**APTUIT RESPONSE TO
NRC REVIEW OF LICENSE AMENDMENT REQUEST REGARDING
DECOMMISSIONING PLAN AND REQUEST FOR ADDITIONAL
INFORMATION – APTIUIT, LLC (MAIL CONTROL NO. 579062)
February 20, 2013**

Attachment 1
Figure 1

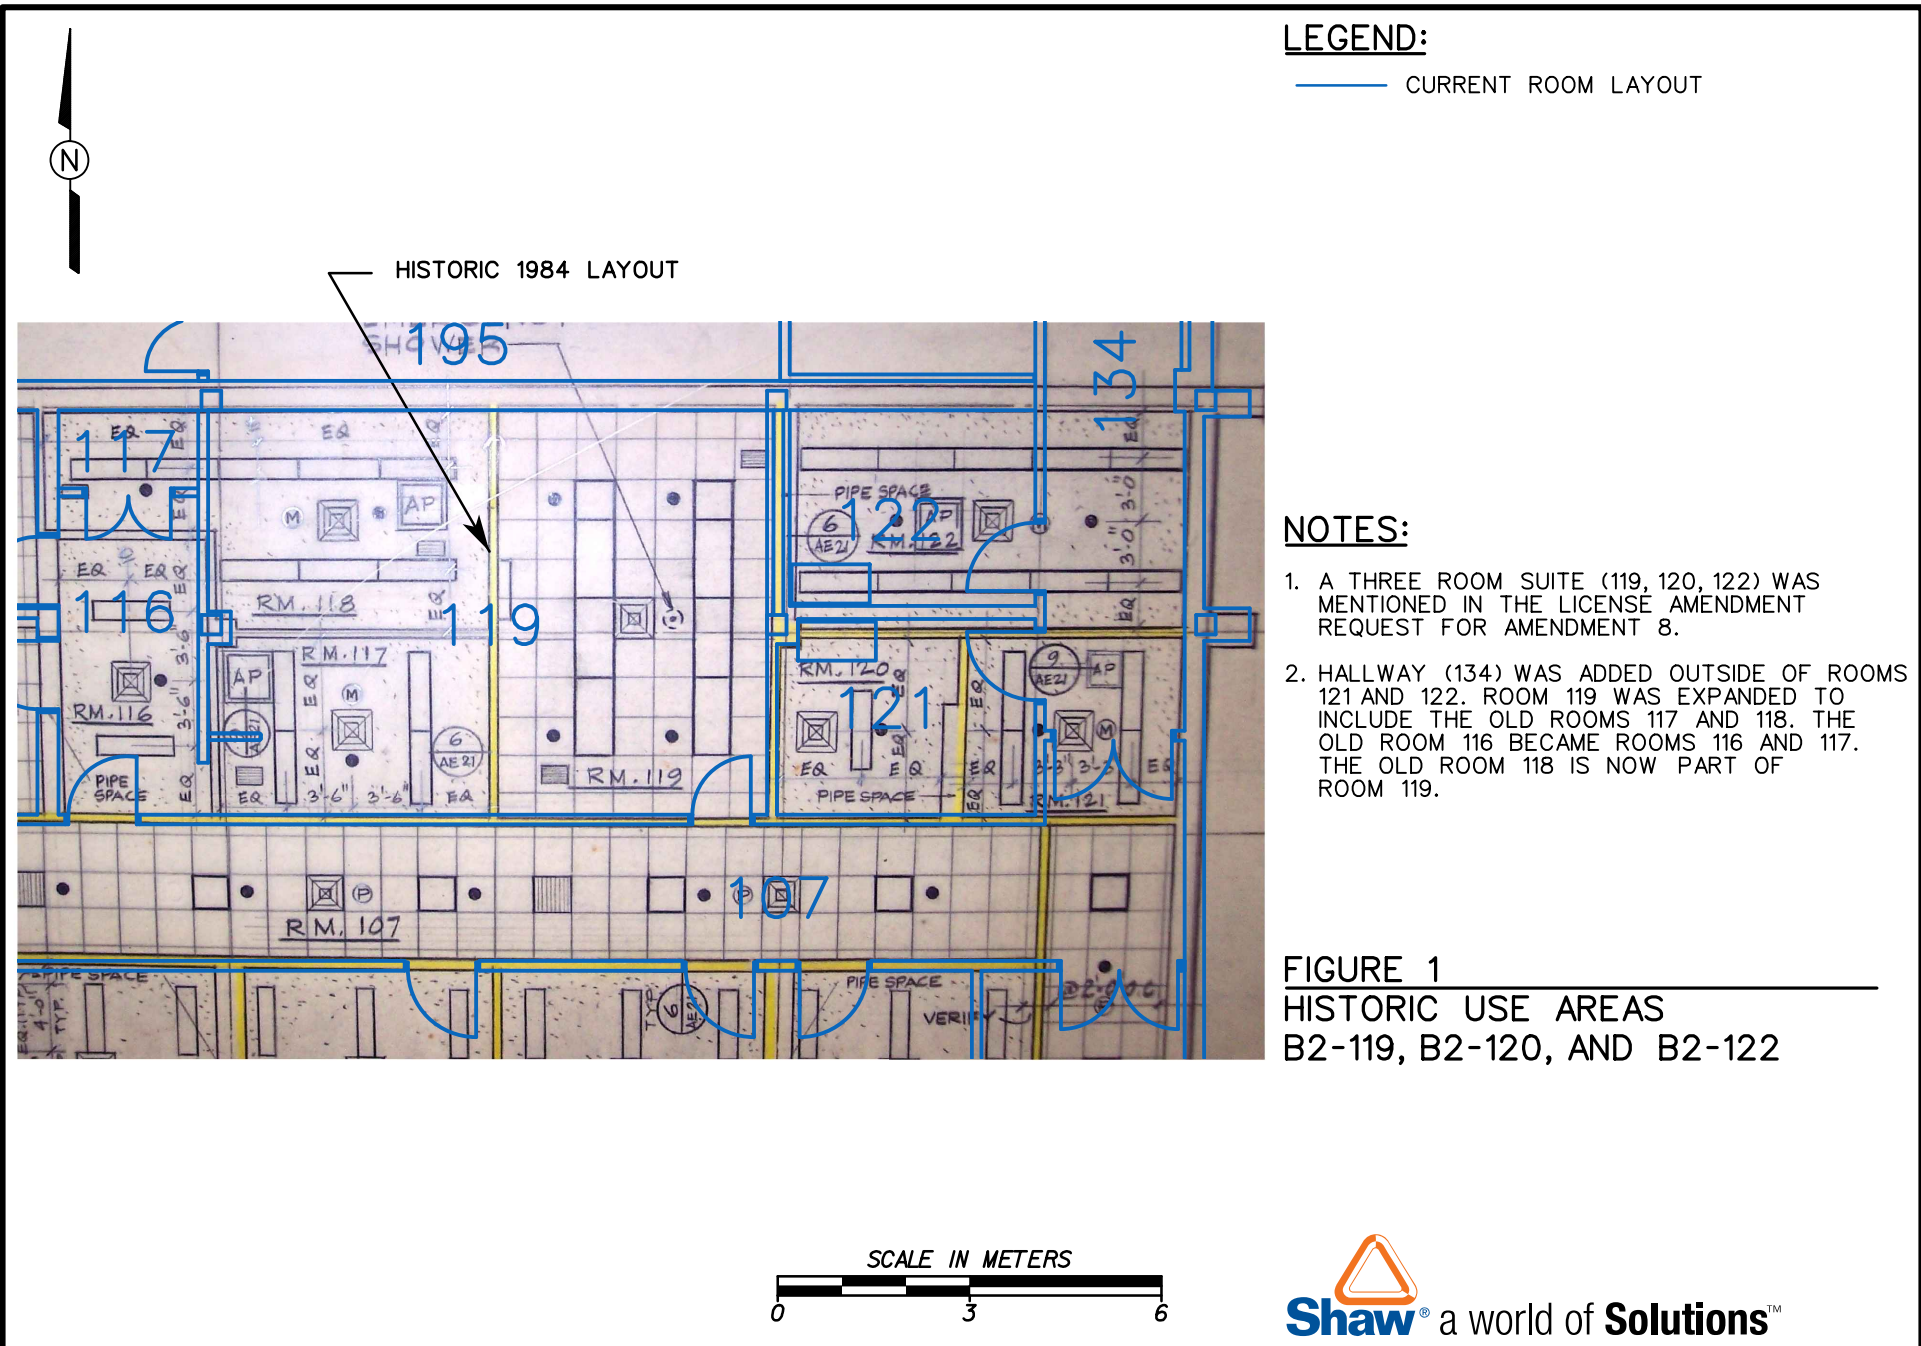
RAI-003: The licensee is requested to provide additional information associated with the physical location of the “3 room suite” as described in the comments section for the line item of Amendment No. 8 of Table 1-1.

The “3 room suite” consisting of Rooms 119, 120, and 122 was mentioned in the application for Amendment No. 8. Aptuit has determined that these rooms were in the B Building. This area has been renovated as shown in the attached figure (Attachment 1, Figure 1) with an overlay of the existing area. Room 119 mentioned in the Amendment No. 8 application is included as part of the current B2-119 decommissioning. Rooms 120 and 122 have been renovated into the current rooms

B2-121 and B2-122 and hallway B2-134. Scoping surveys have been performed in B2-121, B2-122, and B2-134 to confirm that these areas are not impacted. Scoping surveys consisted of scanning and biased direct measurements and wipes. Results of scoping surveys verify that these areas are not impacted. All results were below Aptuit's acceptable surface contamination levels of 5,000 dpm/100 cm² total activity and 1,000 dpm/100 cm² removable activity. Figure 2-7 and Appendix D of the DP, Historical Use Areas, has been revised to address these rooms.

1. A THREE ROOM SUITE (119, 120, 122) WAS MENTIONED IN THE LICENSE AMENDMENT REQUEST FOR AMENDMENT 8.
2. HALLWAY (134) WAS ADDED OUTSIDE OF ROOMS 121 AND 122. ROOM 119 WAS EXPANDED TO INCLUDE THE OLD ROOMS 117 AND 118. THE OLD ROOM 116 BECAME ROOMS 116 AND 117. THE OLD ROOM 118 IS NOW PART OF ROOM 119.
